# Minimum SECQ Change to Allow Receiver Sensitivity Margin

IEEE P802.3dB TF Ad Hoc, 06/24/2021

# Proposed Spec Changes to 8023db D1p1 - TX

# Proposal to Finalize Receiver Sensitivity

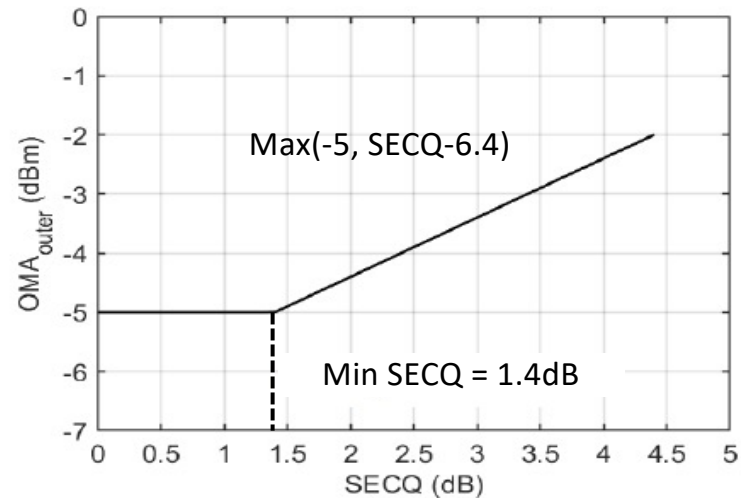
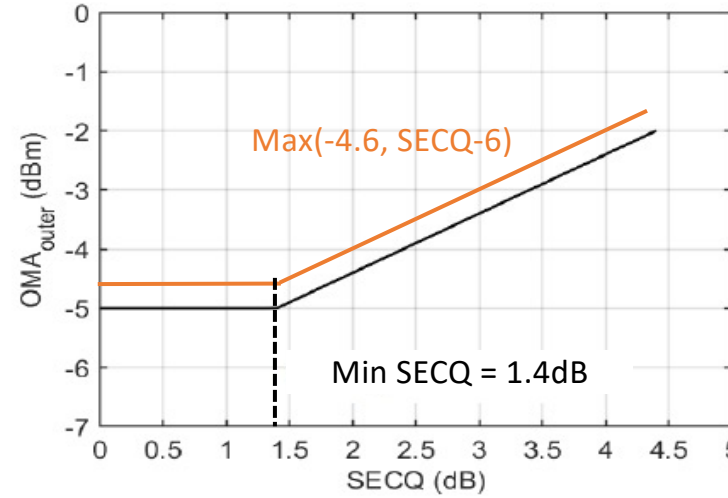
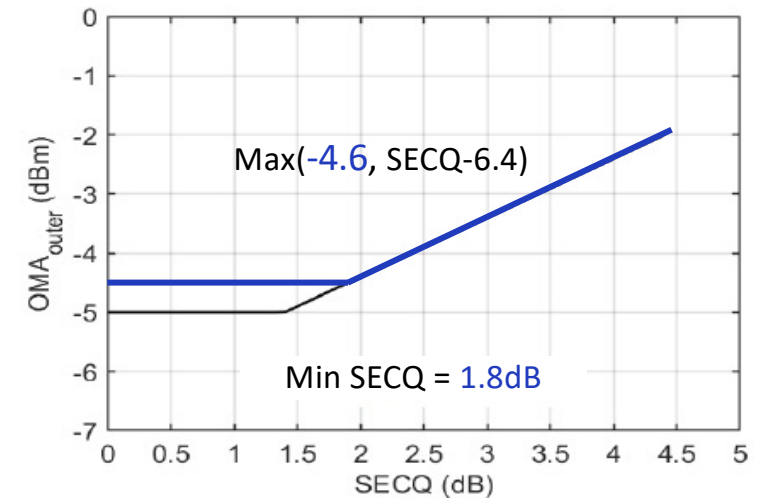
Options	Upside/Downside
<u><a href="#">murty_3db_adhoc_01b_121720.pdf</a></u> : -2.0dBm SRS	<ul style="list-style-type: none"> <li>allocates 1.5dB relaxation on receiver sensitivity that only covers theoretical SNR penalty resulted from 50 Gb/s to 100 Gb/s change</li> <li>Potential problem in the <b>noise limiting region</b> particularly for <b>CMOS TIA implementation</b>.</li> </ul>
<u><a href="#">nering_3db_01_021821.pdf</a></u> : -1.6dBm SRS	<ul style="list-style-type: none"> <li>Allows additional 0.4dB receiver sensitivity margin throughout SECQ range.</li> <li><b>Squeezes TX operating range</b> – requires min TX OMA (for TDECQ=4.4dB) to change from 0.0dBm to 0.4dBm.</li> </ul>
Proposal: Raise minimum SECQ from 1.4dB to 1.8dB; maintain the RS curve based on -2.0dBm SRS above 1.8dB SECQ.	<ul style="list-style-type: none"> <li>Allows some receiver sensitivity margin gain in the noise limiting region (SECQ &lt; 1.8dB).</li> <li>Does not squeeze TX operating range with TDECQ above 1.8dB. Min TX OMA (for TDECQ=4.4dB) remains 0.0dBm. Only affected TX operating region with TDECQ below 1.8dB.</li> </ul>

Proposal

Figure 167-4—Illustration of receiver sensitivity

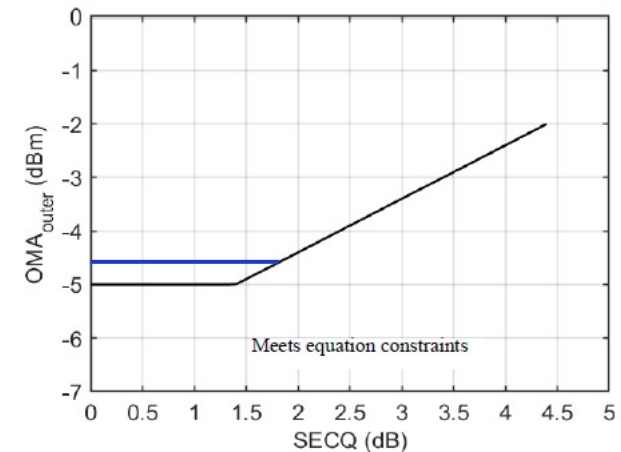
## • 167.8.12 Receiver sensitivity

$$RS = \text{Max}(-4.6, \text{SECQ}-6.4) \quad (\text{dBm})$$
